Evaluation Report 196

Will-Rich 13CPW (11.3 m) Heavy Duty Cultivator

WIL-RICH 13CPW CHISEL PLOW

FIGURE 7. Sweep Pattern (305 mm shank spacing).

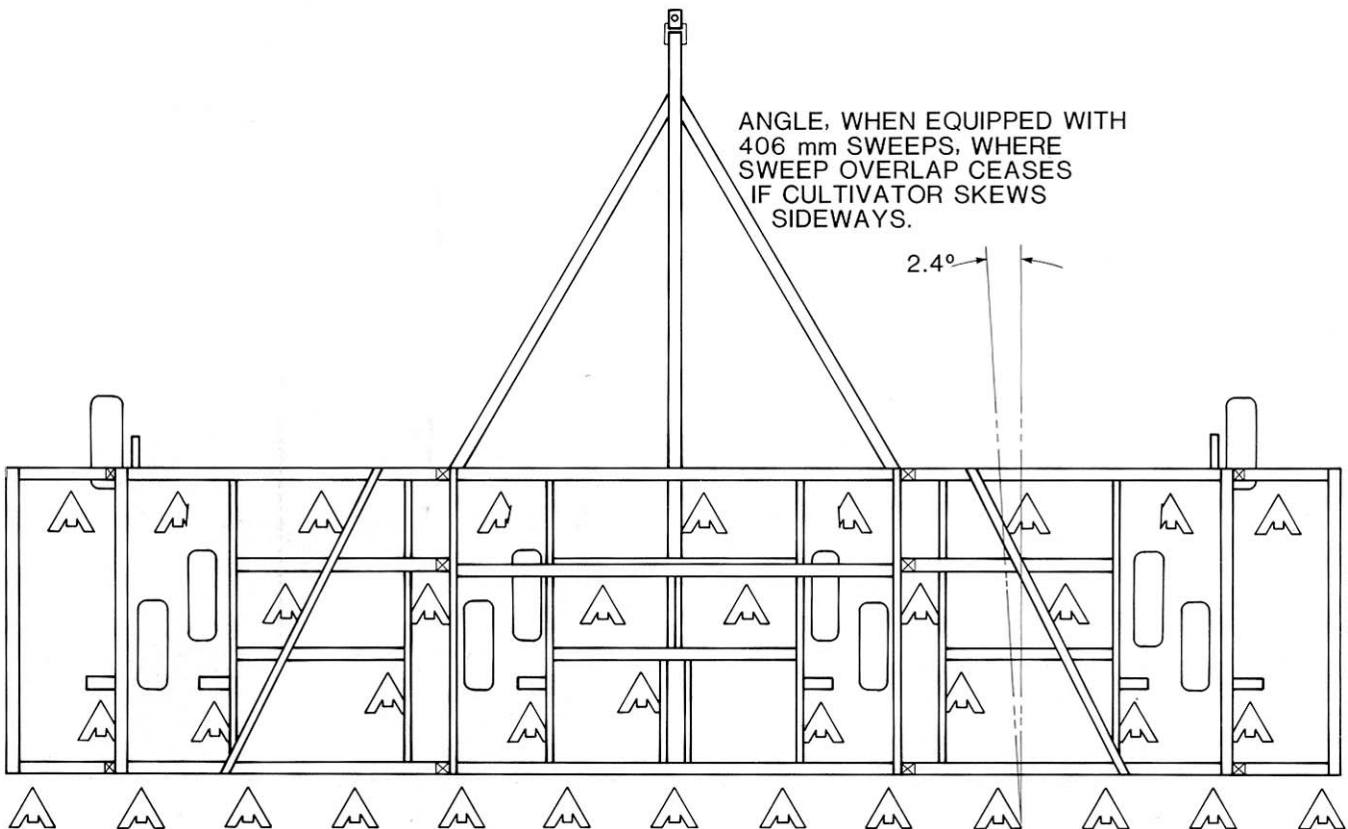
Skewing and Stability: The Wil-Rich 13CPW skewed considerably on side slopes or in heavy draft conditions where soil varied in hardness across the width of the machine. The sweep pattern (FIGURE 7), however, was symmetrical and did not impose any resultant side forces on the cultivator during normal operation. With 406 mm (16 in) sweeps, as used on 33 of the 37 shanks, the cultivator had to skew more than 2.4° for weed misses to consistently occur across the cultivator width. Trimmed sweeps (FIGURE 8) were used on the 4 shanks adjacent to the wheels, and the cultivator had to skew only minimally for weed misses to occur at these locations. Moderately hilly ground caused sufficient sideways skewing for frequent weed misses by the trimmed sweeps.

It is recommended that shanks be arranged on the cultivator to avoid the use of trimmed sweeps adjacent to wheels.

FIGURE 12. Stabilizer Wheel Mount Stub.

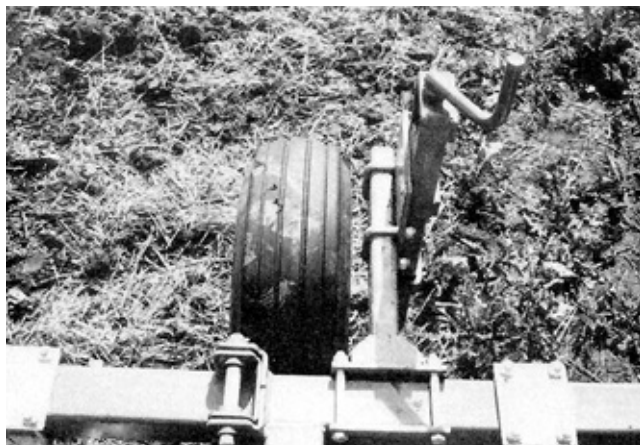
Stabilizer Wheels: The stabilizer wheel mount twisted during operation, resulting in moderate wheel misalignment (FIGURE 12). It is recommended that the stabilizer wheel mount stub be strengthened to retain proper wheel alignment during operation.

The stabilizer wheels rubbed on their mounts during operation. It is recommended that the stabilizer axles be extended to give adequate clearance between the wheels and mounts.

2. To accommodate several different installations and clearances, the stabilizer wheel axle assemblies are designed so that they can be mounted in six different ways. Alternate mounting would have eliminated interference. A heavy duty castoring stabilizer wheel is also available.

FIGURE 14. Shank Holder Interference with Frame.

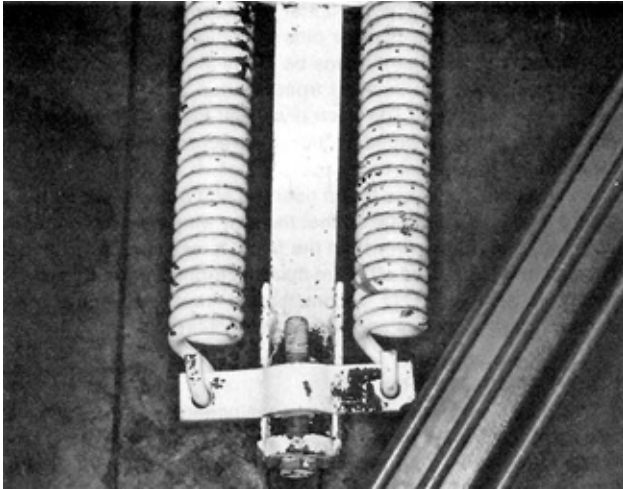
Shank Interference: When positioned according to the manufacturer's recommendations, shanks on both wings, when tripped, interfered with diagonal frame members, causing shank holder damage (FIGURE 14). It is recommended that the shanks and frame members be positioned to avoid interference.

4. Shank interference with frame members can be avoided by moving the affected shanks laterally by as little as 6 mm (0.25 in). Shank placement practices will be considered on all future major redesigns.

FIGURE 15. Shank Holder Pivot Failures.

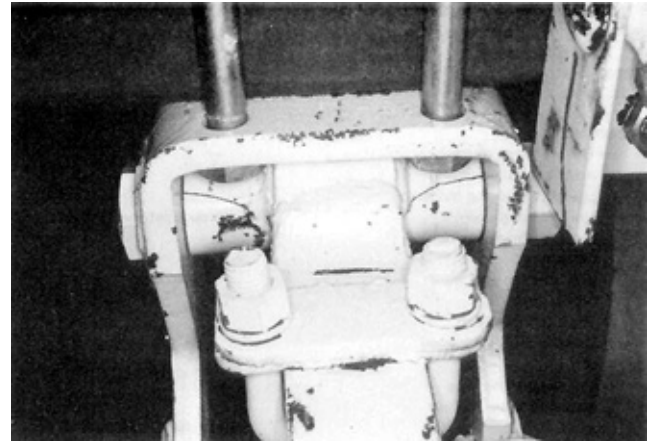
Shank Holder Pivot Failures: The pivots of 19 shank holders cracked as shown in FIGURE 15. It is recommended that the pivots be strengthened to prevent such breakage.

3. Failures typical to those experienced by PAMI were traced to a vendor supplying inferior tubing material, which once detected, was immediately corrected. The material specifications have been upgraded and the quality control inspection practices tightened.
